Appendix D16_Competenet Authority Comments

**NOTICE OF BASIC ASSESSMENT AND WATER USE LICENSE APPLICATION PROCESS
FOR THE PROPOSED AMENDMENT OF MINING RIGHT 80 MR FOR THE EXPANSION OF
THE KWEZI MINING OPERATIONS THROUGH THE INCLUSION OF THE UG SHALLOWS
BLOCKSRUSTENBURG LOCAL MUNICIPALITY, NORTH WEST PROVINCE**

SUBJECT : COMMENTS/ CONSENT IN TERMS OF ACT NO 21 OF 1940 AND ROADS ORDINANCE NO 22 OF 1957 AS AMENDED: NOTICE OF CONSULTATION BASIC ASSESSMENT AND WATER USE LICENSE APPLICATION PROCESS FOR THE PROPOSED AMENDMENT OF MINING RIGHT NW 80 MR AND THE EXPANSION PF THE KWEZI MINING OPERATIONS THROUGH THE INCLUSION OF THE UG SHALLOWS BLOCKS (A & B) SITUATED IN RUSTENBURG LOCAL MUNICIPALITY, NORTH WEST PROVINCE

**DRAFT BASIC ASSESSMENT REPORT FOR THE PROPOSED AMENDMENT OF
MINING RIGHT AND THE EXPANSION OF THE KWEZI MINING OPERATIONS
THROUGH THE INCLUSION OF THE UG SHALLOWS BLOCKS (A & B)
NW30/5/1/2/2/80 MR.**

MINIMUM BUILDING LINE RELAXATION

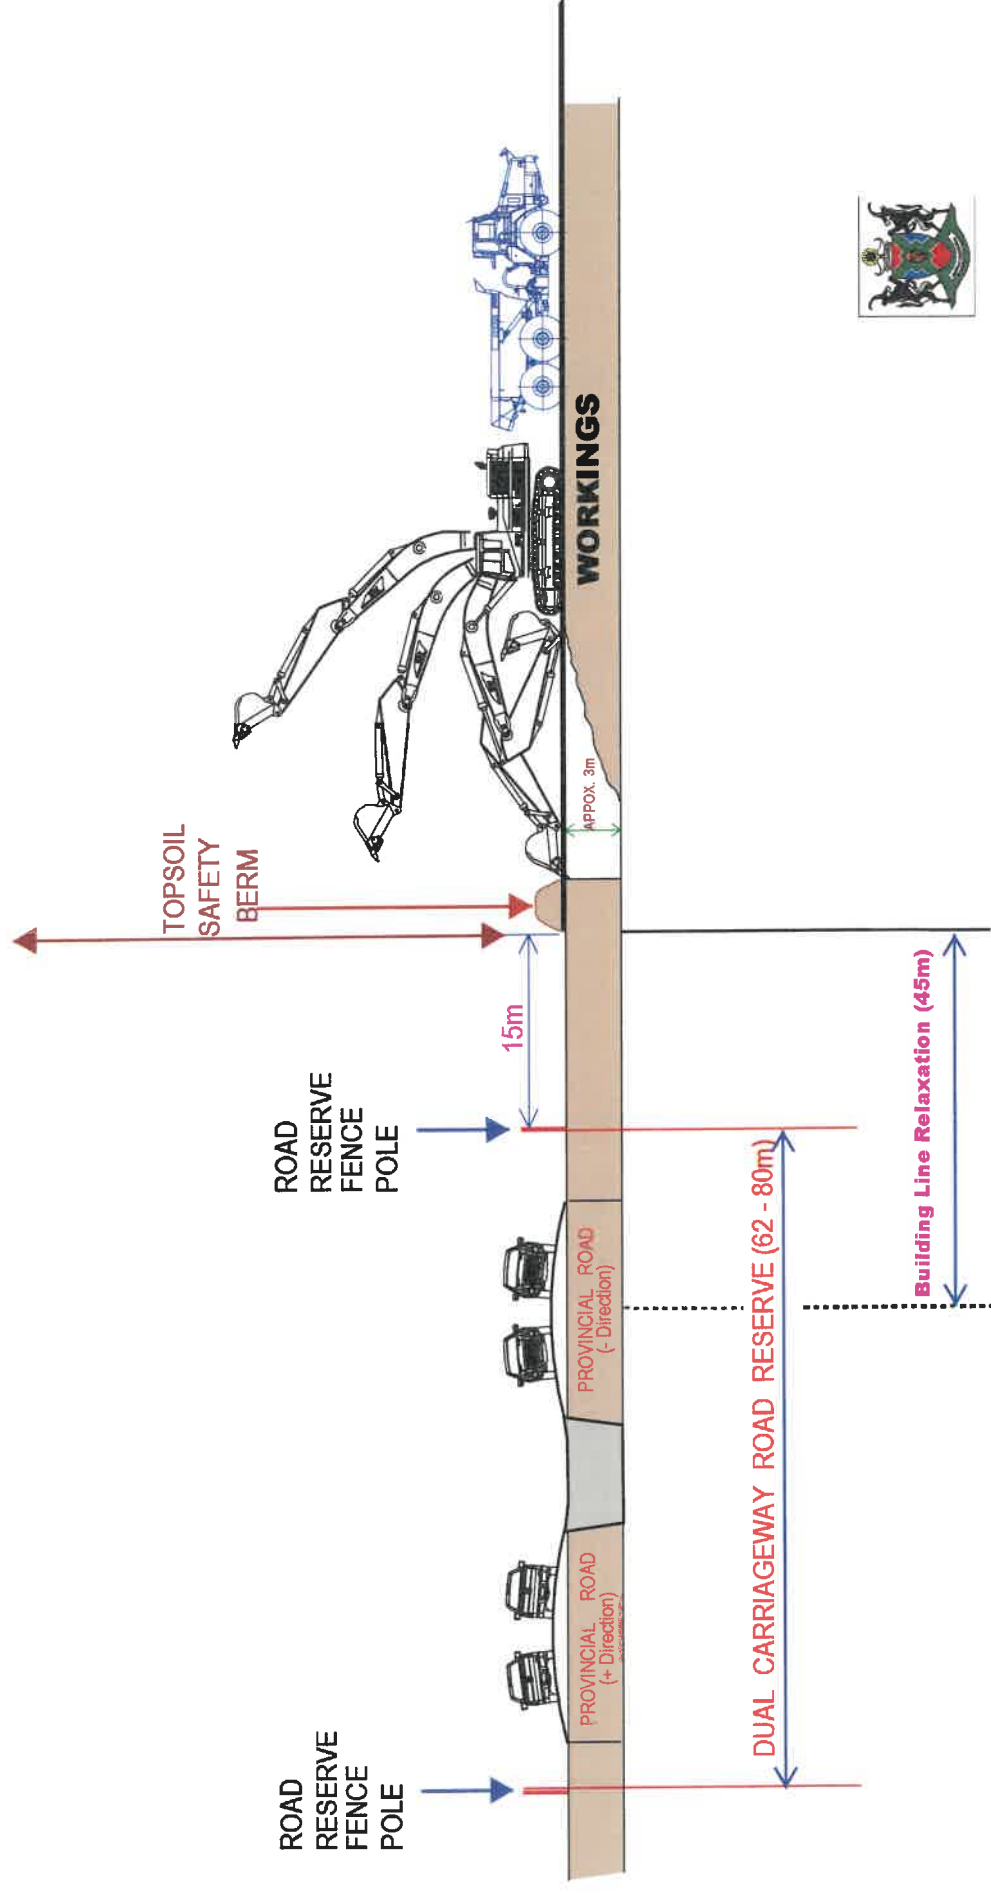
e. BUILDING LINE RELAXATION

The *Department of Public Works and Roads (DPWR)* is hereby grant the **minimum relaxation of the building line** from the **Standard 95m** as stated by **Clause 4: Standard Building Line** above as follows.

Also see the attached *Sketch Plans Road Reserve Width(s)*.

- i. **Road Reserve Width of 62m** : The Building Line Relaxation is **45m** from the centre of the Road Reserve; (*i.e. 15m from road reserve boundary*).

Locality Map

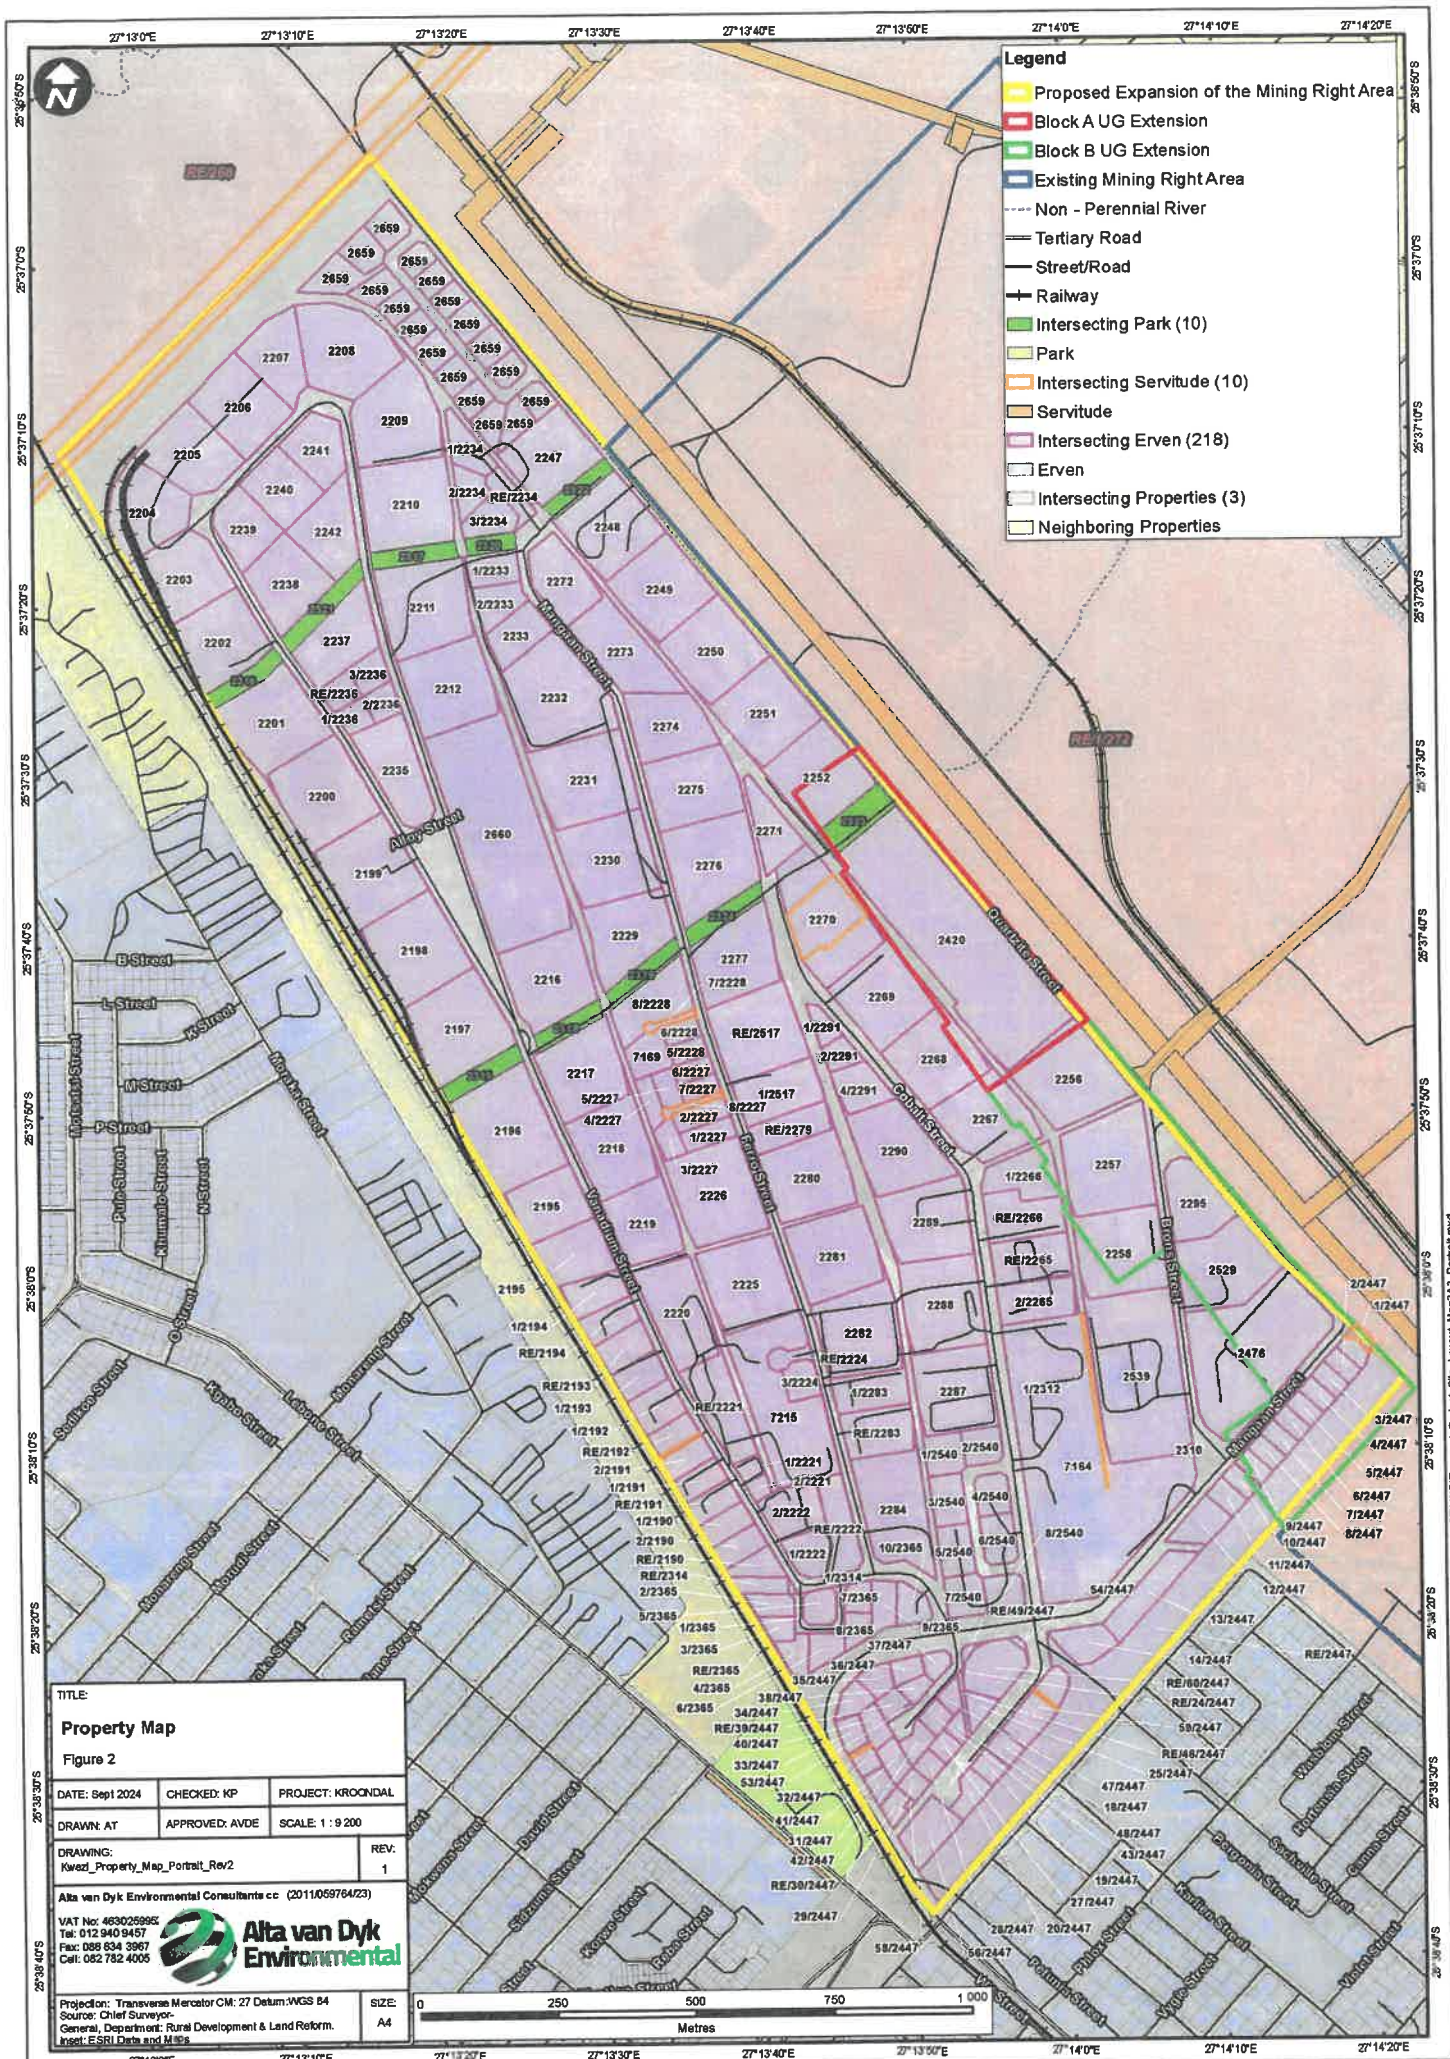
The existing and future/ planned provincial road(s) should be excluded from the proposed development(s). For more information see the attached **Locality Map_NW 30-5-1-2-2_80 MR_Sibanye RPM**.

The existing access(es) to the affected land i.e. **Locality Map_NW 30-5-1-2-2_80 MR_Sibanye RPM** will be utilised/ used for the above-mentioned development(s).
